Access Compliance Report

Public Rights-of-Way

(Curb Ramps)

Intersection ID: 15833	Main Street: SOUTH_BV	Cross Street: CLANTON_RD	Location: SE
ADA ID: F882B5CBF135	Ramp Type: Perp	Initial Pass/Fail: Fail	Overall Compliance: No
		Severity Score: 12.5

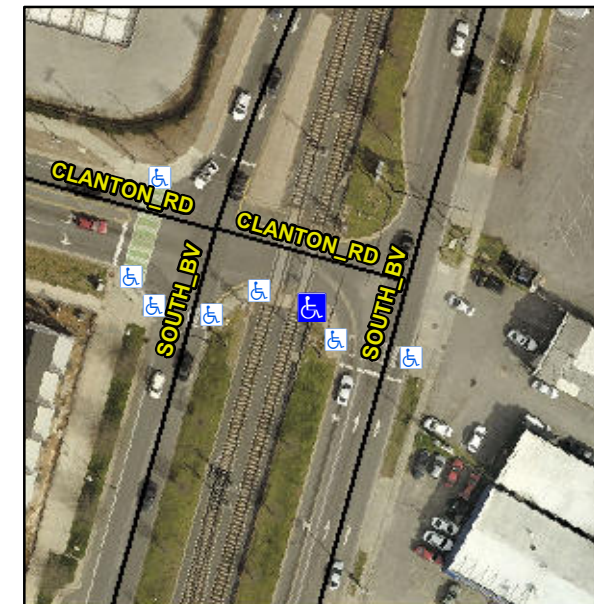
R304.2.2

Compliance	Description	Data	Compliance	Description	Data
N/A	Ramp Length (in)	94.0	No	Ramp Slope (%)	9.4
Yes	Ramp Width (in)	75.0	Yes	Ramp XSlope (%)	1.7
N/A	Flare Type LT	N/A	N/A	Flare Type RT	N/A
N/A	Flare Slope LT (%)	N/A	N/A	Flare Slope RT (%)	N/A
N/A	Flare Traversable LT?	N/A	N/A	Flare Traversable RT?	N/A
N/A	Landing Length (in)	N/A	N/A	DWS Provided?	N/A
N/A	Landing Width (in)	N/A	N/A	DWS Contrast?	N/A
N/A	Landing Slope (%)	N/A	N/A	DWS Length (in)	N/A
N/A	Landing X Slope (%)	N/A	N/A	DWS Full Width?	N/A
N/A	Landing Curb? (Y/N)	N/A	N/A	DWS Offset (in)	N/A
N/A	Shared Landing?	N/A			
N/A	Gutter Ponding?	N/A	N/A	Gutter Slope (%)	N/A
N/A	Gutter Lip Ht (in)	N/A	N/A	Gutter X Slope (%)	N/A
N/A	Painted X Walk1?	No	N/A	Painted X Walk2?	N/A
	X Walk 1 Direction	To NW		X Walk 2 Direction	N/A
N/A	X Walk 1 Width (in)	N/A	N/A	X Walk 2 Width (in)	N/A
	X Walk 1 Slope (%)	0.8		X Walk 2 Slope (%)	N/A
	X Walk 1 X Slope (%)	0.3		X Walk 2 X Slope (%)	N/A

Remove & Replace Entire Ramp.
